Bottoms Gallery (pvt) Ltd. (New Location)

12 February 2024

2. Observations

Prepared loan plan on 1st floor

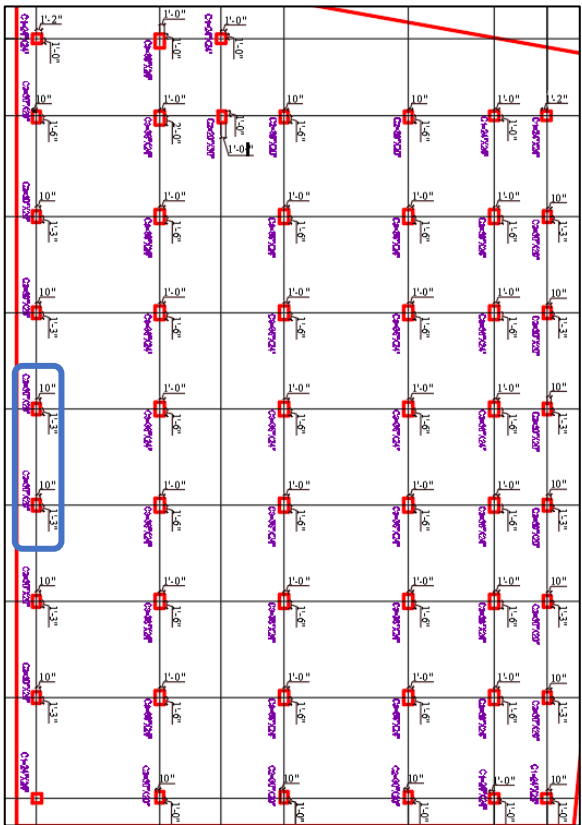
Observation-01: The design report and load plan need to be revised. (Building-1)

Description: Live load on storage area of Ground and 1st floor is considered as 3 kPa in prepared load plan. As per BNBC-2006, live load for light storage areas is required to be considered minimum 6 kPa. Therefore, the factory engineer is required to revise the load plan as per BNBC requirement and check the design report accordingly.

Column layout plan

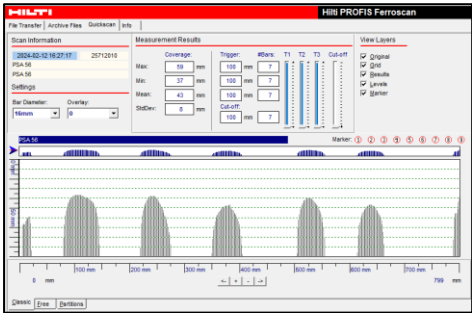
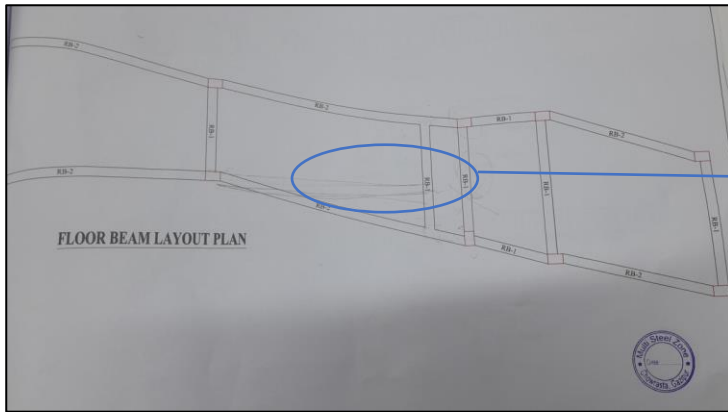
Observation-02: Discrepancies in as-built drawings. (Building-1).

6 nos rebar was found by ferro scan instead of 7 in Column C2 shown in column schedule.

Description: During inspection, 6 nos rebar was found by ferro scan instead of 7 in long face of Column C2 shown in column schedule. The building engineer is required to survey the structure and prepare full set of as-built drawings.

Beam layout plan (Building-2)

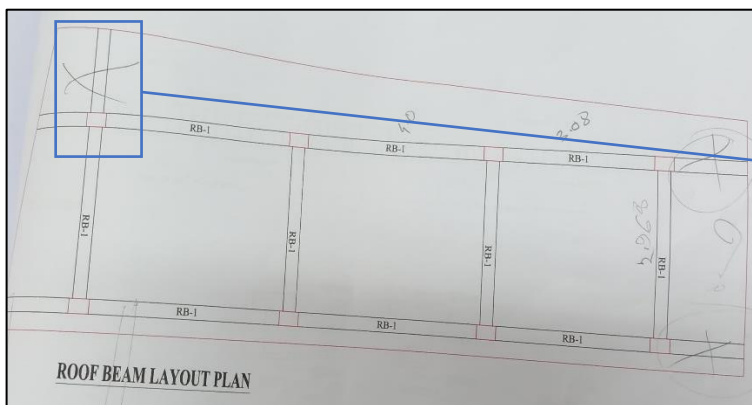
Observation-04: Mismatches in as-built drawings. (Building 02 & 03).

Description: During inspection mismatches between beam layout plan and onsite condition were observed for Building 2 & 3. The building engineer is required to survey the structure and prepare full set of as-built drawings.
